SUBJECT: ADDENDUM # 2

PROJECT TITLE: Energy Upgrades
Milford Courthouse
14 West River Street Milford, Connecticut

PROJECT NO.: **BI-2B-315**

BID OPENING	**1:00 P.M.**	**MARCH 31/2010**
ADDENDUM NUMBER 2	**DATE OF ADDENDUM**	**MARCH, 18, 2010**

1 RTU-1 PART PLAN

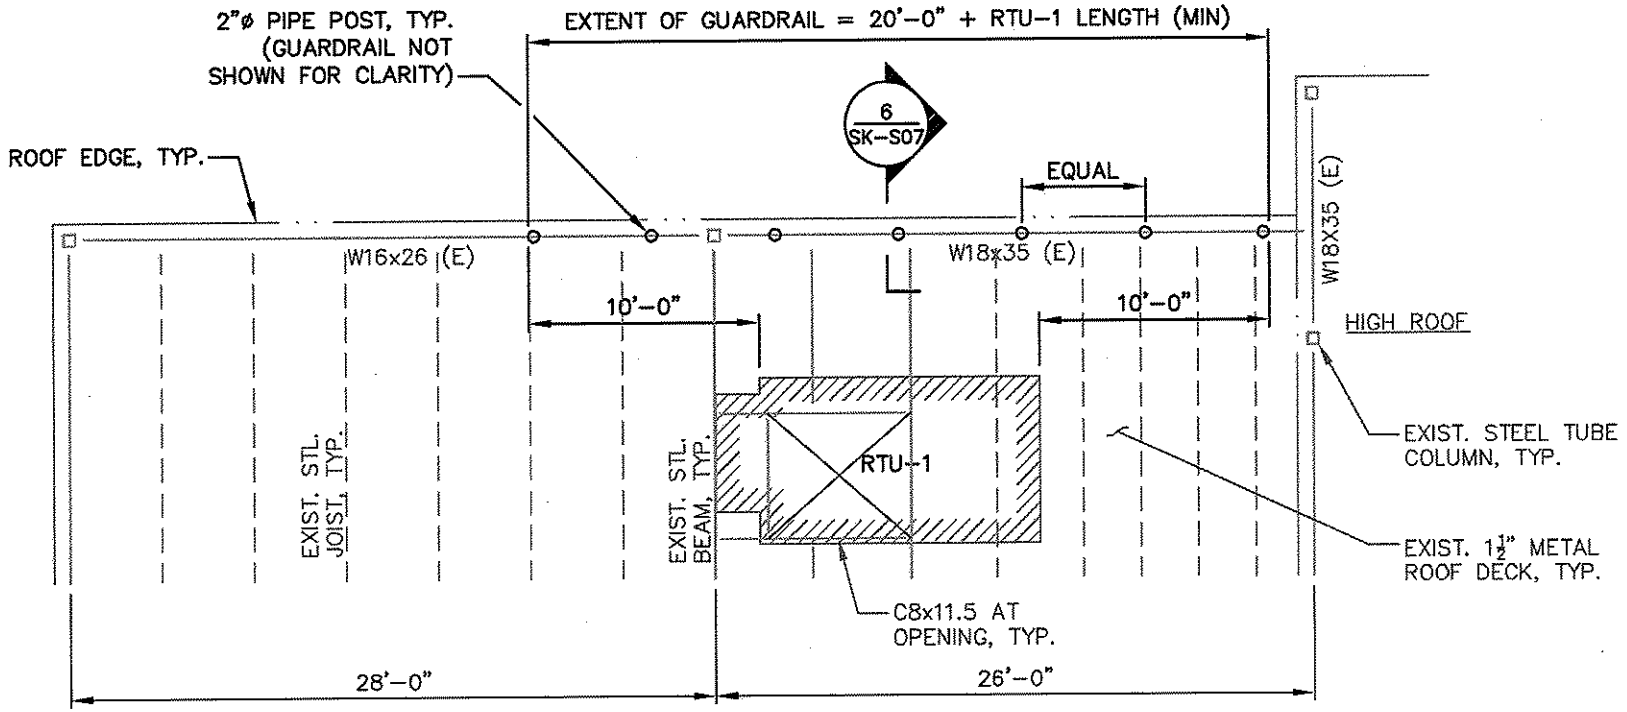
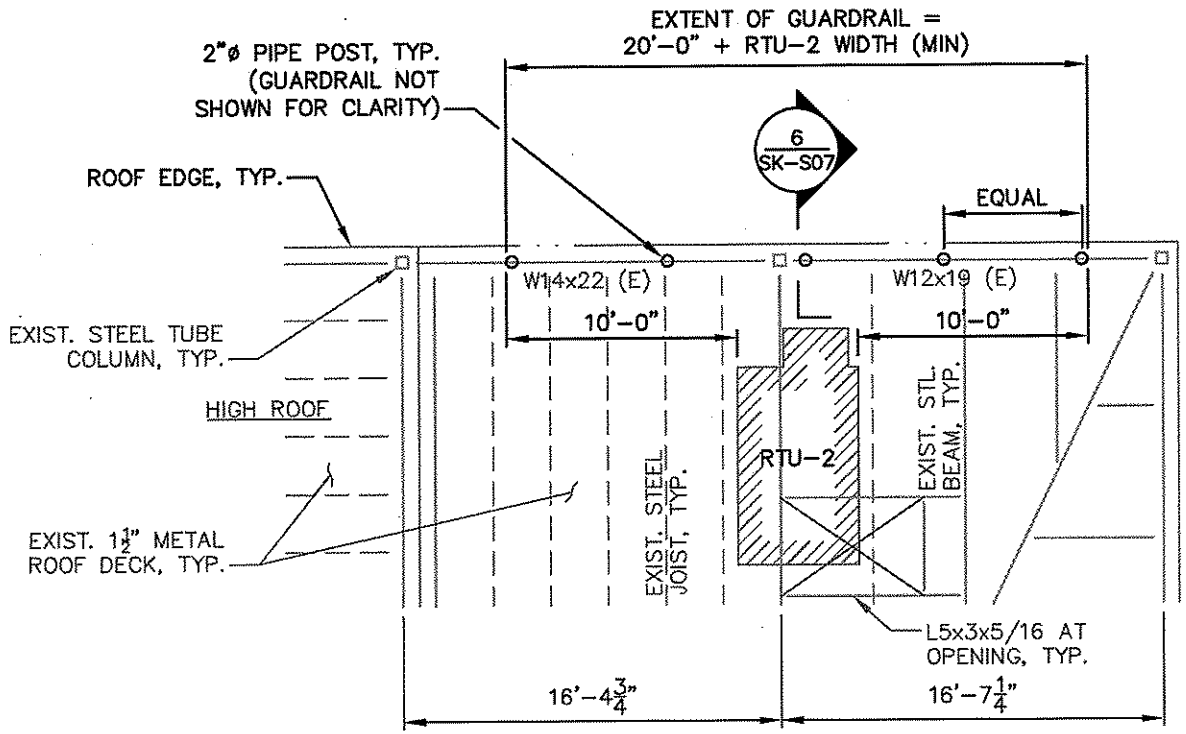
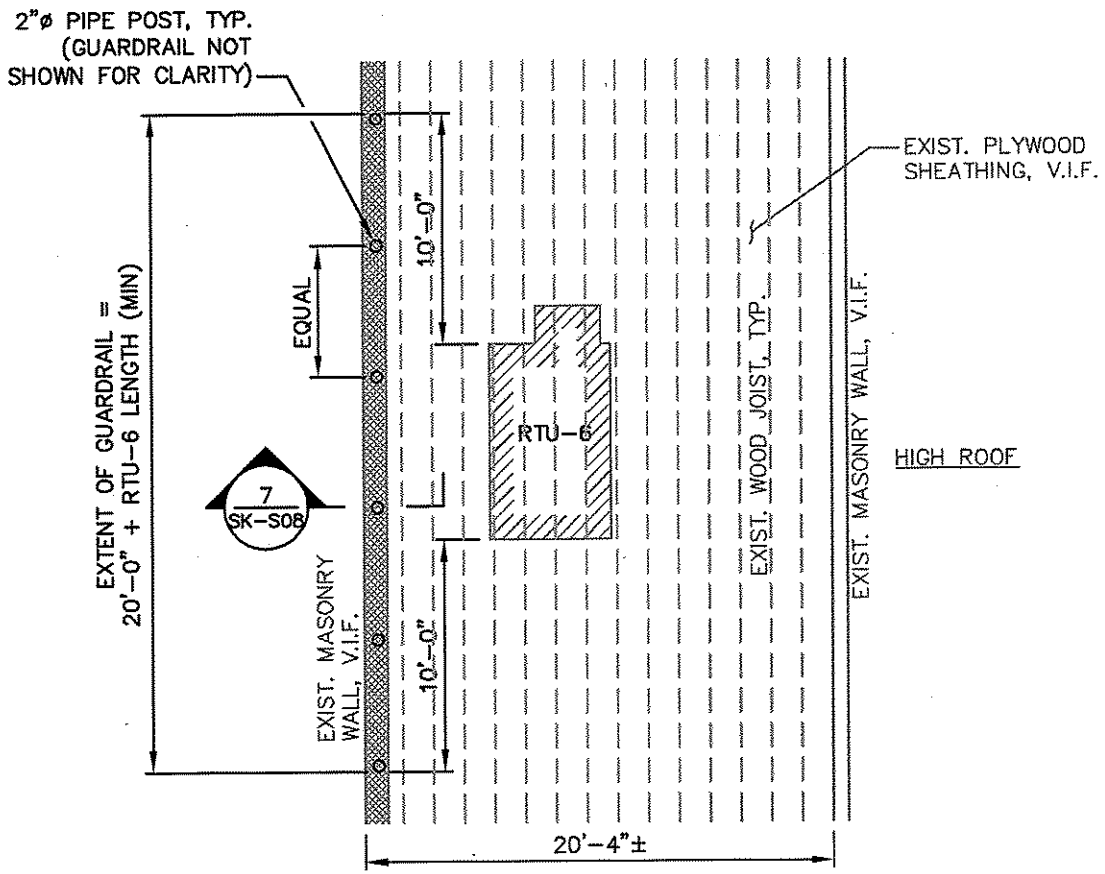
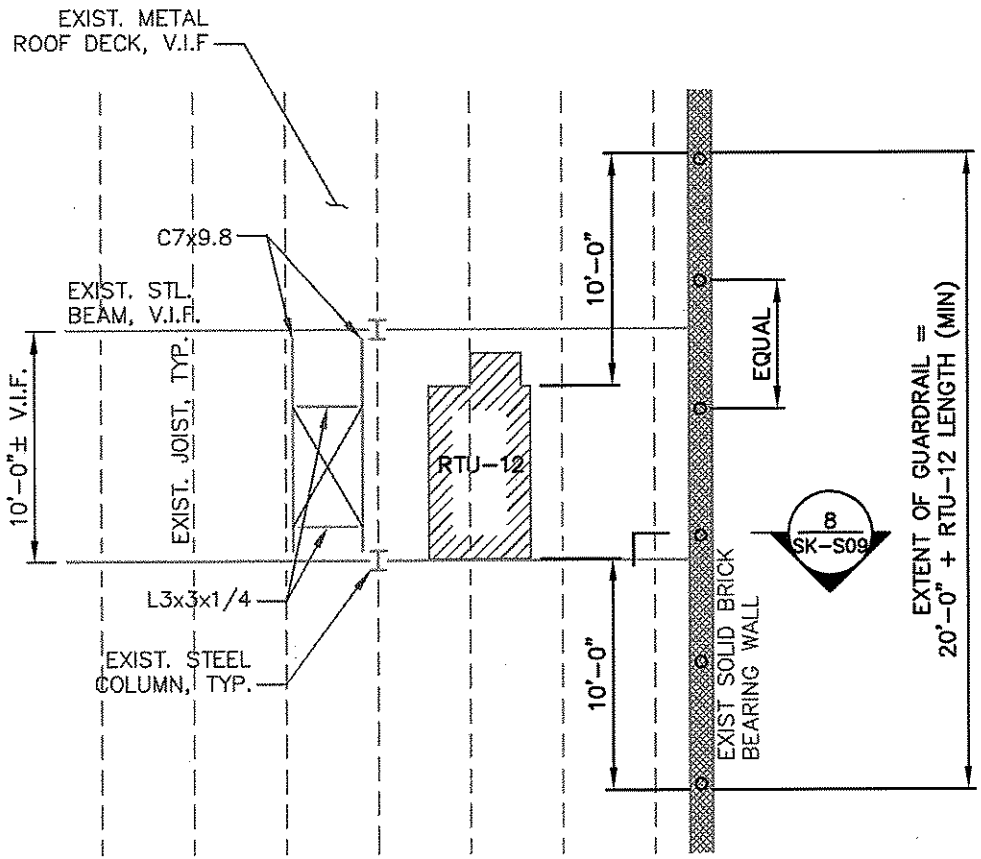
Add scope of work to drawing M-1.3 indicated by attached sketches SK-S01 thru SK-S09.

5 TYPICAL GUARDRAIL DETAIL

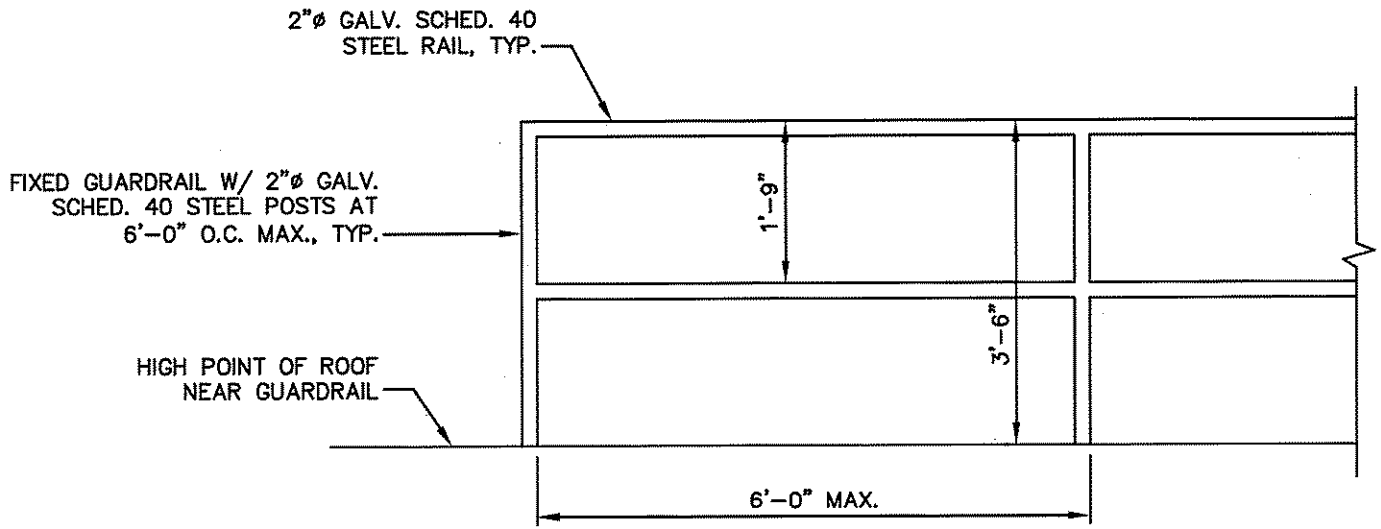
NOTES:
1. SEE DETAILS 6/SK-S07, 7/SK-S08, AND 8/SK-S09 FOR POST CONNECTIONS TO EXISTING STRUCTURE.
2. POST AND HORIZONTAL RAIL DIMENSIONS ARE TYPICAL U.N.O.

1 CONDENSING UNIT DEMOLITION PLAN

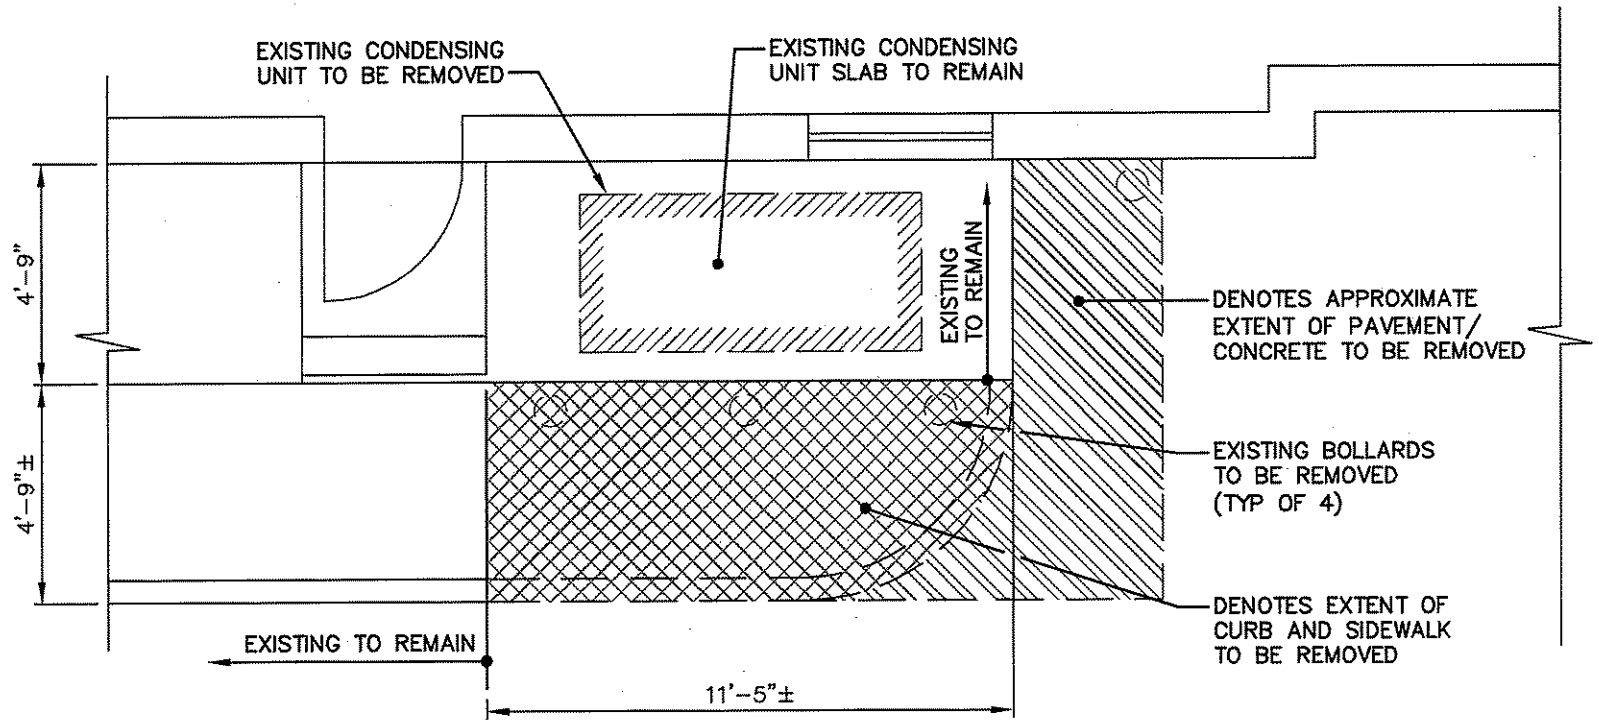
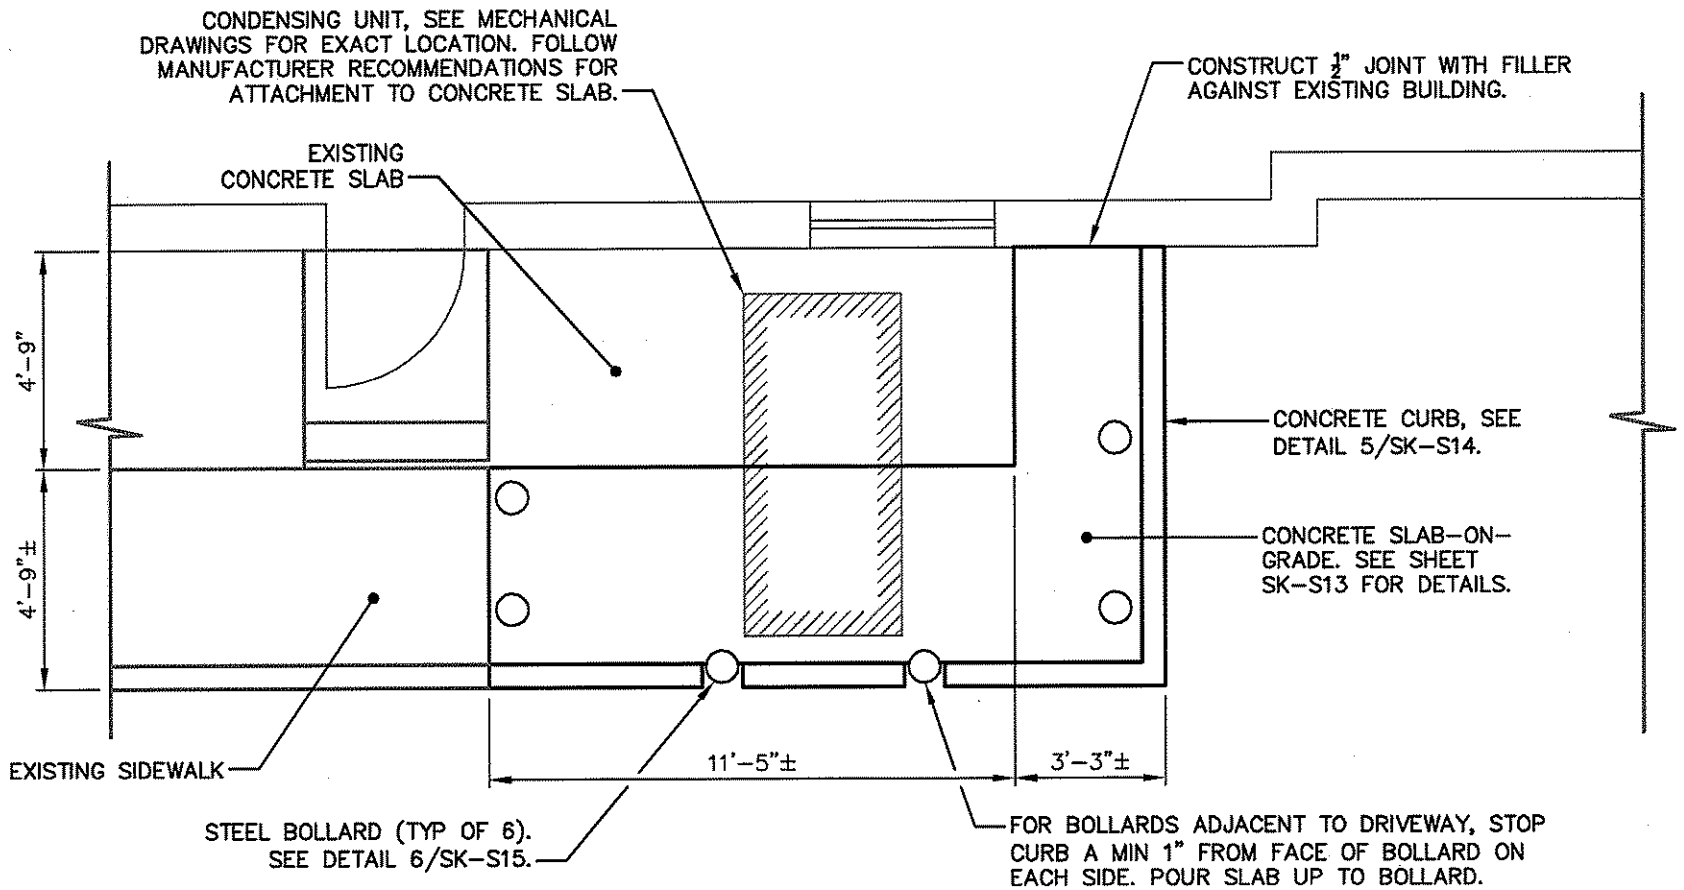
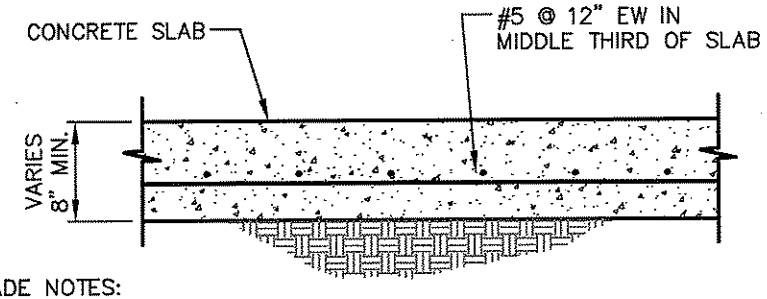
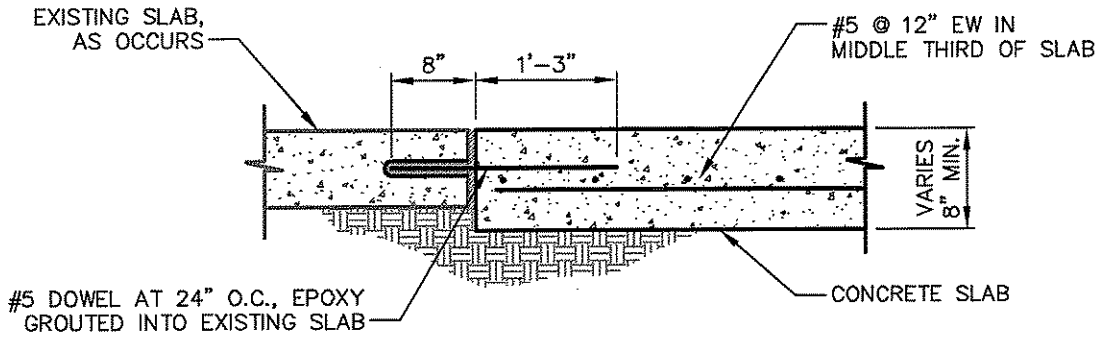
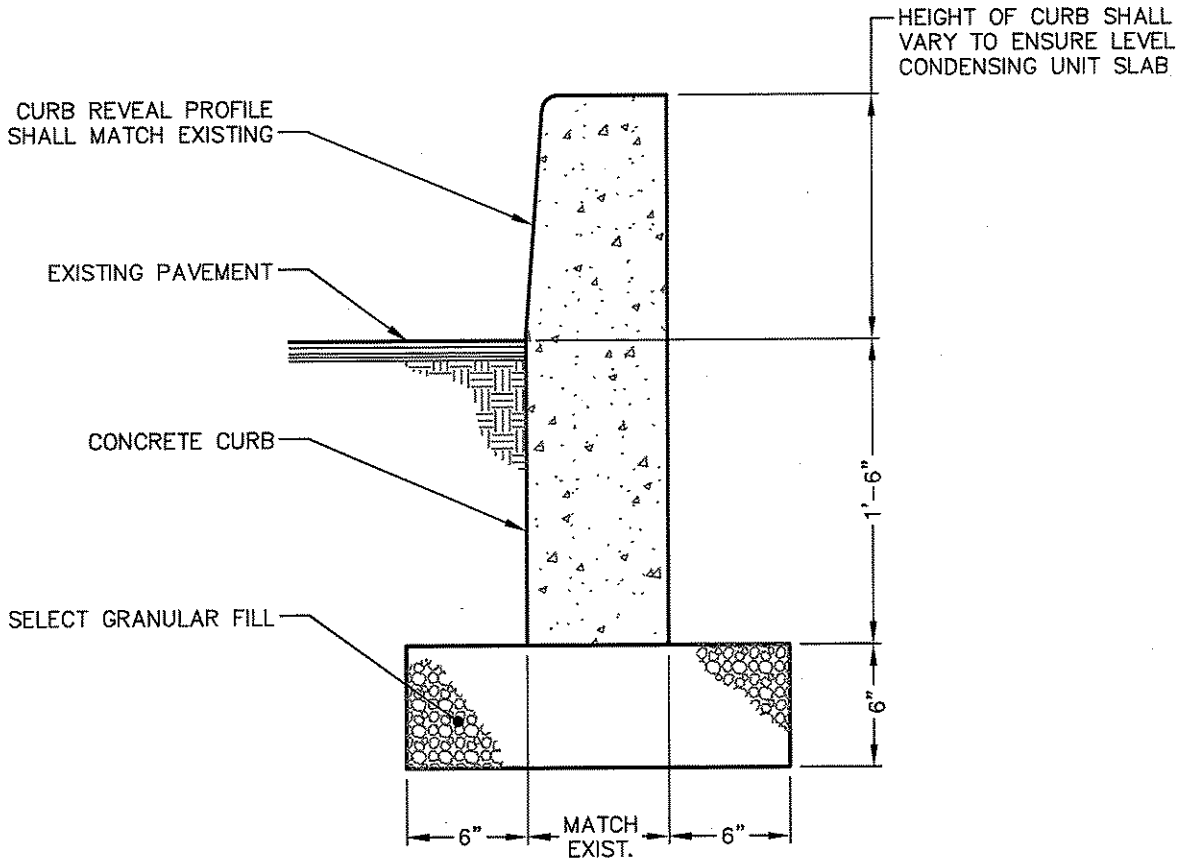
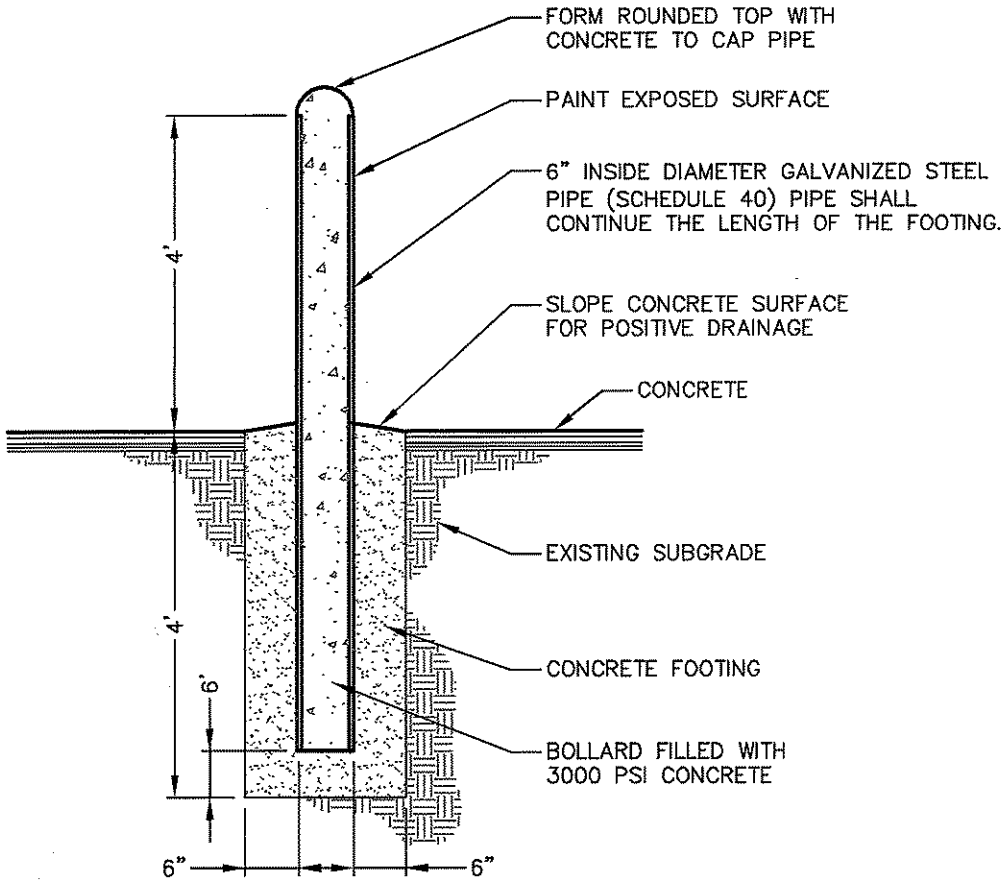
Add scope of work to drawing M-1.1 indicated by attached sketches SK-S10 thru SK-S15.

SKME1.0

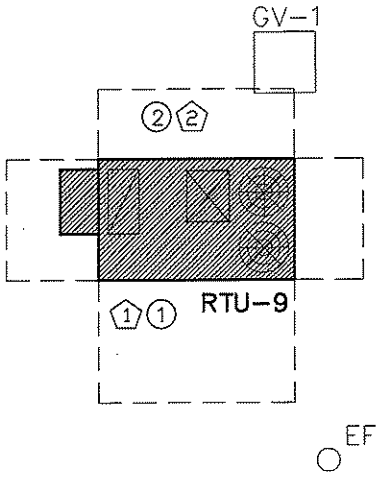
Add Alternate #1, RTU-9 replacement to scope of work on drawing M-1. Additional scope of work for Alternate #1 is indicated on attached sketch SKME-1.0. Break out price of work for RTU-9 replacement, and provide a separate cost for the Alternate #1.

1. REMOVE EXISTING ROOFTOP UNIT AND REPLACE WITH NEW RTU-9.
2. PROVIDE CURB ADAPTER. PERFORM FIELD MEASUREMENTS OF EXISTING CURBS PRIOR TO ORDERING ADAPTER CURBS. MODIFY AND EXTEND GAS PIPING AS REQUIRED FOR CONNECTION TO NEW RTU.

1. EXISTING ELECTRICAL BRANCH CIRCUIT ASSOCIATED WITH MECHANICAL EQUIPMENT SHALL REMAIN IN PLACE FOR CONNECTION TO NEW EQUIPMENT.
2. PROVIDE FINAL CONNECTION TO NEW EQUIPMENT. CHANGE CIRCUIT BREAKER FOR EXISTING BRANCH CIRCUIT TO 60 AMP, 208 VOLT, 3-POLE IN EXISTING POWER PANEL. CONDUIT AND CONDUCTORS SHALL BE REUSED.
